Hearing Examiner Exhibit

Applicant
Department ADMITTED
Public DENIED
FILE # CF-314356

From: Karen
To: Examiner, Hearing
Cc: PRC
Subject: Comment on Shared Roof- HE File Number CF-314356, SDCI Record Number 3023260-LU
Date: Monday, May 07, 2018 1:47:26 PM

Comments re 7009 Greenwood Contract Rezone for 3023260 CF 314356

Exhibit A for 23.47A.014
Seatabck abutting a side or rear lot line of a residentially zoned lot

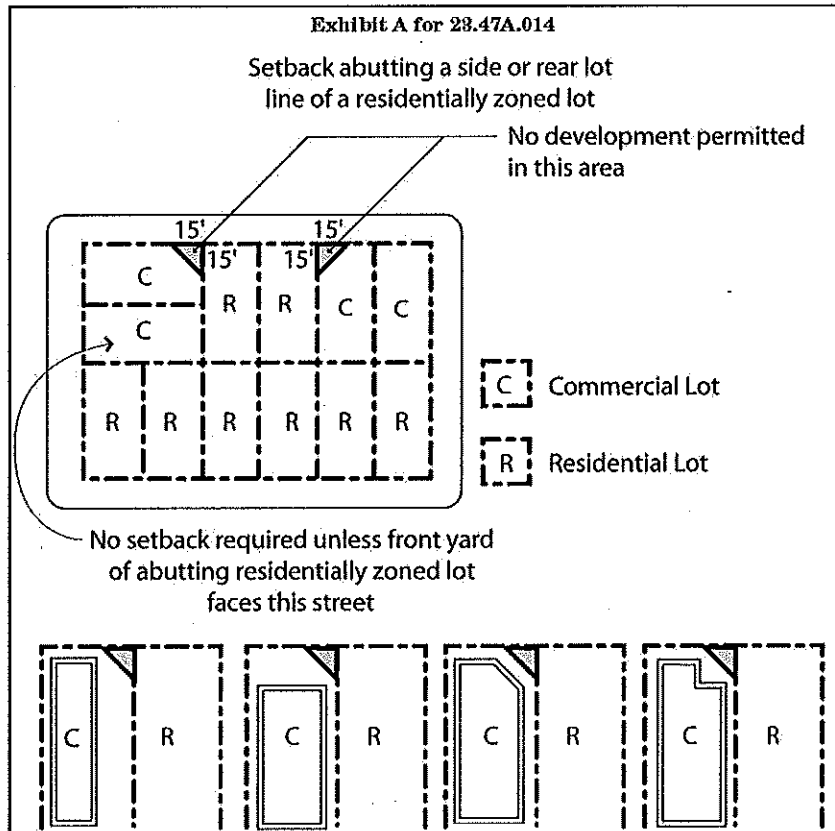
7009 violation: The southwest corner of the building comes right up to the property line in violation of SMC 23.47A.014.B.1. Various alternative design options are shown in Exhibit A to SMC 23.47A.014.B.1.

Exhibit C for 23.47A.014 Setbacks for Structures with Residential Uses When Abutting a Residentially-Zoned Lot

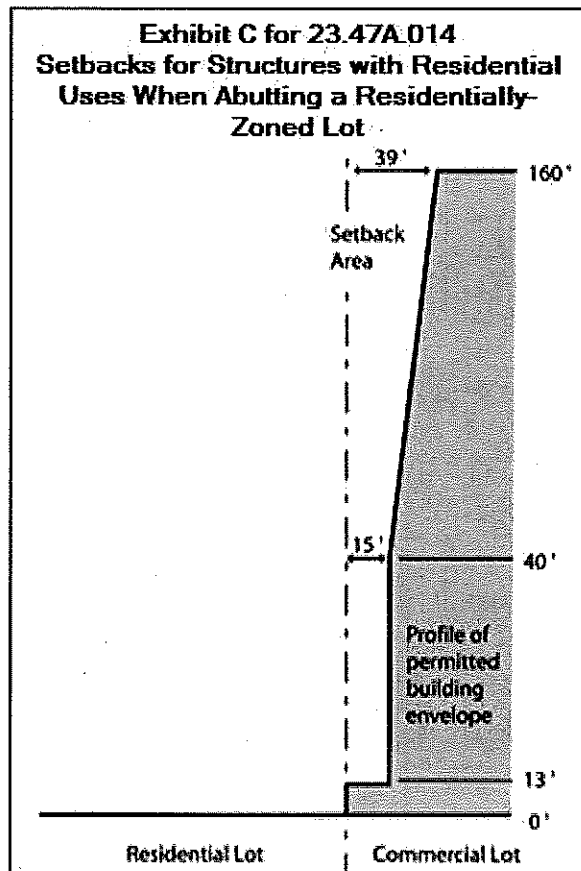
7009 violation: All floors above the first floor are built within the required setback area in violation of SMC 23.47A.014.B.3. The massive greenhouse appears to be less than 15' from the line (page A206). Based on elevations shown on page A300-303, the 40 foot elevation (where even more than a 15-foot setback is required) occurs before the ceiling of the 4th floor). The greenhouse appears to be 67 feet tall.
